RE: Smiles for Kids Dental Office – Site Expansion
Conceptual Grading and Drainage Plan
Stamp Date: 06/01/18
Hydrology File: C12D056

Re: Smiles For Kids – West Site: Tract G – Fountain Hills
Hydrology Resubmittal Memo

CONCEPTUAL GRADING & DRAINAGE PLAN

C100

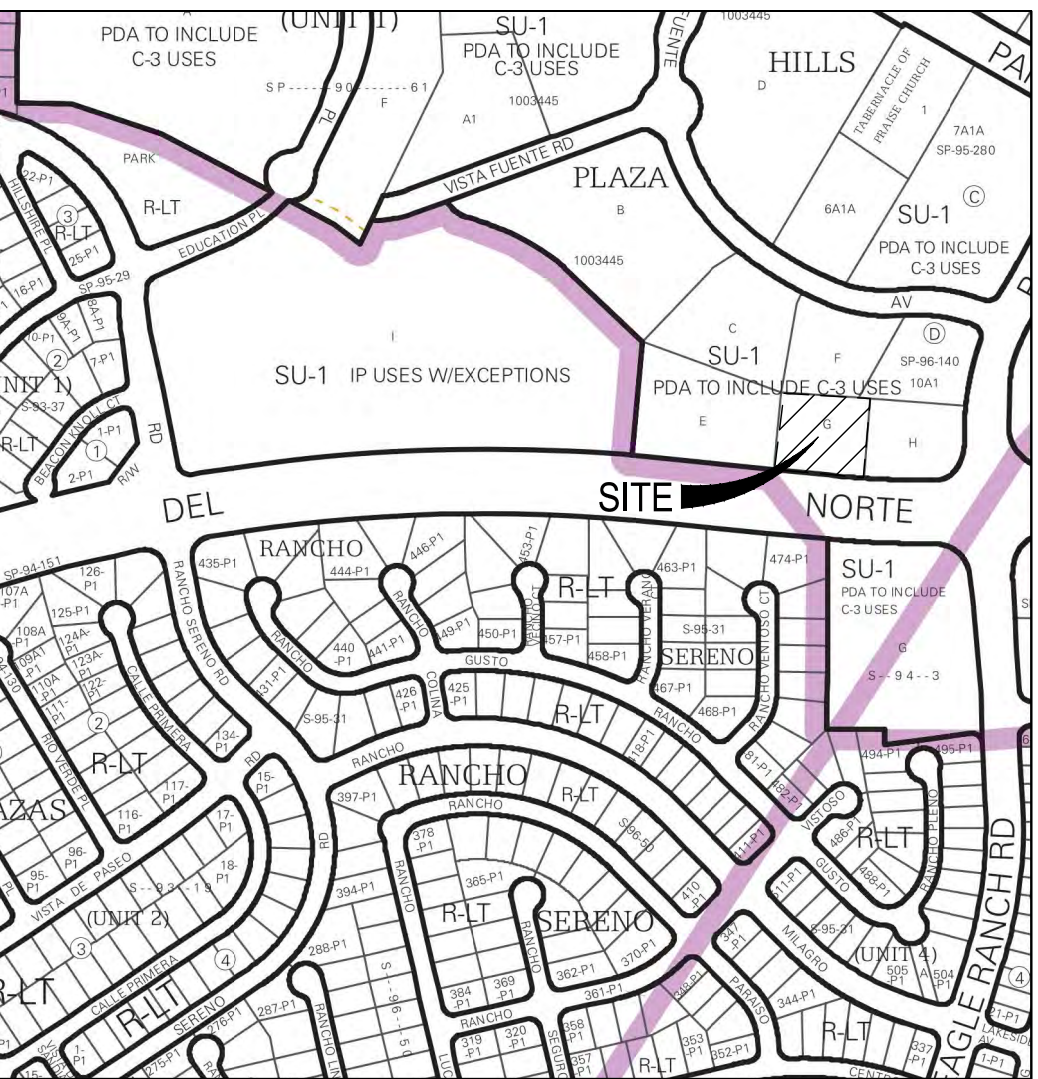
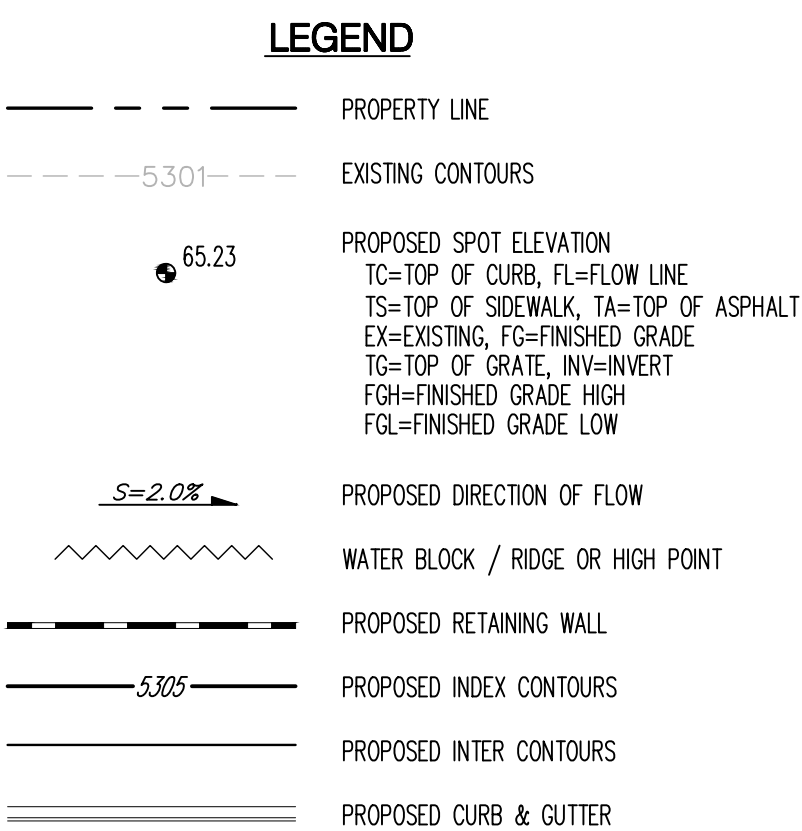
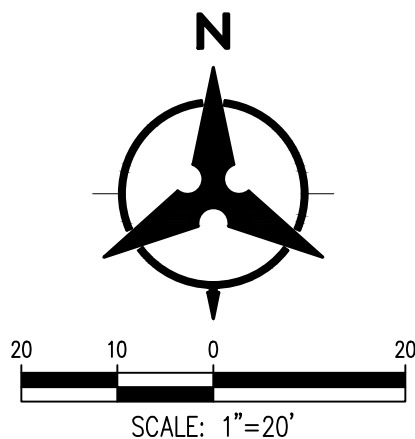
Since you are only providing 95 cubic feet of the required first flush volume of 817 cubic feet. The Fee in Lieu payment (Amount = $722 \text{ CF} \times \$8/\text{CF} = \$5,776.00$) for the remainder of the required first flush volume must be made using the attached City of Albuquerque Treasury Deposit form. The Owner needs to bring three copies to the Building Permits and pay the fee. Then provide Hydrology with one copy showing the receipt. This needs to be done prior to Hydrology's approval of the project for Building Permit.

RETENTION AREAS WITHIN TRACT G WILL BE INCORPORATED INTO THE LANDSCAPE AREAS WHERE POSSIBLE. THE FIRST FLUSH CALCULATIONS FOR THE OVERALL DEVELOPMENT AREA ARE SHOWN ON THE DRAINAGE BASIN CALCULATIONS. DUE TO THE STEEP SITE AND LIMITED OPPORTUNITIES FOR SURFACE PONDING THE ENTIRE FIRST FLUSH RETENTION VOLUME COULD NOT BE ACHIEVED WITH SURFACE PONDING. SEE BELOW FOR FIRST FLUSH CALCULATIONS:

- VOLUME REQUIRED: 817 CF
- VOLUME PROVIDED: 95 CF
- VOLUME REMAINING: 722 CF

THE REMAINING FIRST FLUSH VOLUME IS UNATTAINABLE AND WILL BE COVERED VIA THE CITY OF ALBUQUERQUE HYDROLOGY DEPARTMENT'S CASH IN-LIEU PROCESS.
